Madison Cable's (TycoElectronics) comments for T10 letter Ballot "Forwarding SSM to First Public Review (01-237r0)" as follows:

After review the document 01-237r0, we would like to suggest the following changes to be made to the documents before forwarding it to the public review.

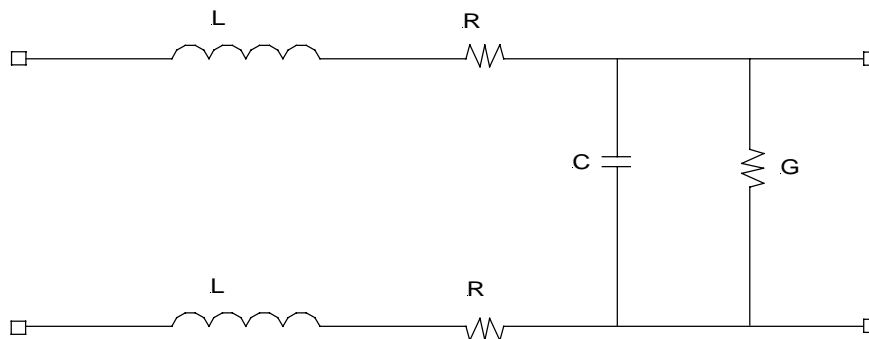
Change#6: on page 43, line 14, add:

The format of the circuit model is as follow:
